Docket Item # 16
BAR CASE # 2008-0193

BAR Meeting
November 5, 2008

ISSUE: New Construction
APPLICANT: Sophie Development LLC
LOCATION: 714 Wythe Street
ZONE: OC/Office Commercial

Figure 7. Proposed front (north) elevation.

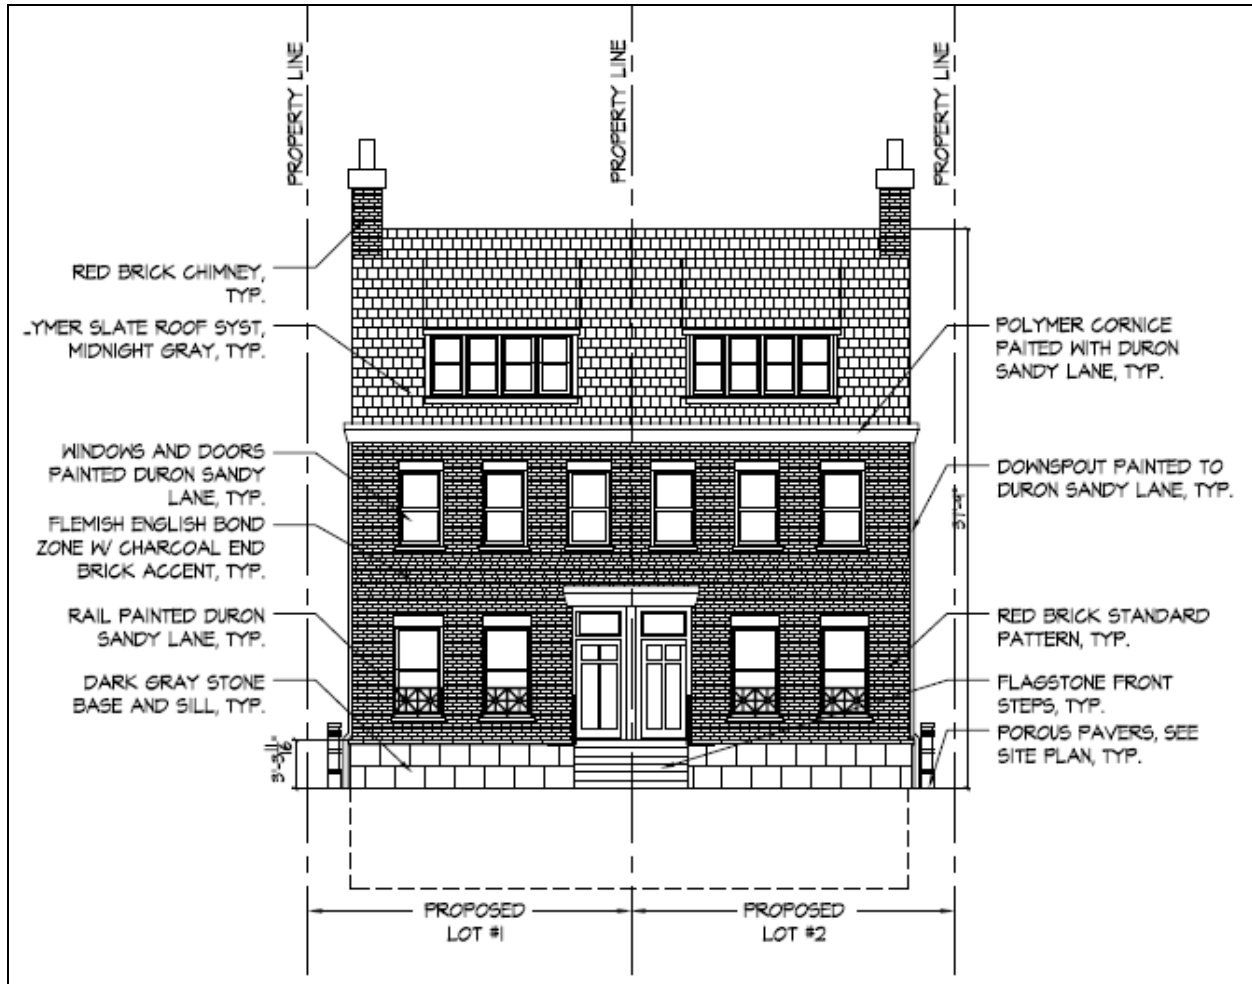
Staff finds that the style, massing, height and fenestration of the front elevation are appropriate. The three-story building reads as a two-story-plus-attic building and reflects the general architectural patterns found throughout the historic district. The first story windows are larger than the second story windows, reflecting traditional fenestration patterns. However, Staff notes that the proposed shed dormer with four single-light windows has no clear precedent in the historic district. The *Design Guidelines* note the following about dormers: “dormer sashes should be operable and should be the same type as the other window sashes on the structure,” “shed dormers are strongly discouraged,” and “dormers should match the existing proportions of the building and the windows.” Staff finds that the proposed dormers do not successfully meet the guidelines on dormers. While a dormer is a very appropriate choice, Staff recommends that the applicant refine the design of the dormer to make it less prominent on this elevation and more compatible with the bay rhythm on this elevation.

Staff also notes that a more historically appropriate approach to this type of building (two townhouses as one building), is to slightly delineate the two dwellings through the application of a small amount of ornament or detailing. Staff does not object to the central entrance but finds that a differentiation of the two townhouses will provide a more accurate reading of the building from the street. The delineation could be accomplished in many historically appropriate ways including, but not limited to, projecting decorative metal coping at the center dividing line on the roof, or refining the entryway to reflect the two entrances through alterations to the stoop or the door surround.

Staff finds that the proposed front door, a four-panel oak door in a Craftsman style, is not appropriate for the architectural style of this building. Staff recommends that the applicant work with Staff for final approval of a wood front door appropriate to the period and style of the building.

1. That the applicant revise the design of the front dormer to make it more compatible with the proposed bay rhythm on the front elevation and to reduce its prominence.

2. That the applicant refine the front elevation to articulate that the building is a pair of townhouses rather than a single residence.
3. That the applicant work with Staff for final approval of a wood front door appropriate to the period and style emulated in the building design.

Figure 8. Proposed side (east and west) elevations.

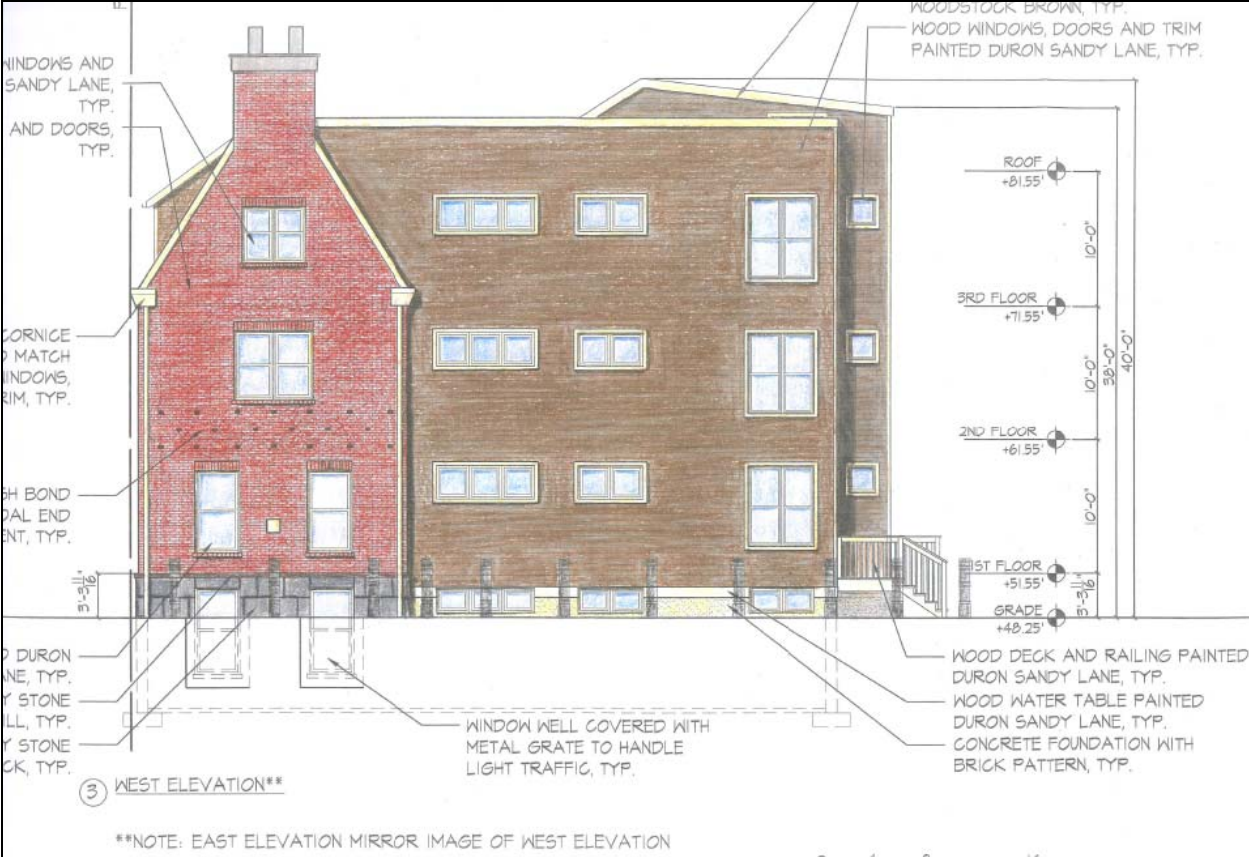
The side elevations are both bounded by public alleys, making the side elevations highly visible. Staff finds that the transition on the side elevations from the brick portion to the frame portion is appropriate. As houses evolve and change over time, the introduction of a new building

material, such as siding on a rear addition to a main block of brick, often occurs. However, what generally makes such different materials and forms successful is that the rear portion is lower than the main block. Staff finds that a slight reduction in the height of the frame portion will provide a more appropriate visual transition from the front of the property to the rear. Staff has concerns that the proposed windows on the frame portion create a side elevation disjointed from the front elevation. While modern uses and needs result in an internal program driving window placement, Staff recommends that the window type and placement be reconsidered. Specifically, the *Design Guidelines* discourage awning windows. Although discouraged, Staff notes that they may be acceptable in a less visible location on this building.

The *Design Guidelines* advise that the adverse effect of meters and vents in visible locations can be “reduced by painting the meter a neutral background color or a color to match the predominant façade color. Staff recommends that the vents on the side elevations be painted a color similar to the brick color so that it recedes from view into the brick wall.

Staff has no objection to the use of porous grass pavers running along the side elevations. Staff is concerned about the use of bollards on this elevation. While Staff recognizes the practical need for installing bollards along the alleys, Staff finds that a vegetative or other type of buffer, would be more appropriate. However, if bollards are to be installed they should be of metal rather than plastic and reduced in number where possible, or concealed as possible.

4. That the applicant revise the fenestration of the side elevations and lower the overall height of the frame portion to create a more cohesive relationship with the front elevation.

5. That the vent in the side elevation be painted a color similar to the brick color so that it recedes from the brick wall.
6. That the applicant consider an alternative protective screen for the side elevations other than bollards, such as a vegetative screen. If bollards are to be used, they should be made of metal rather than synthetic material.
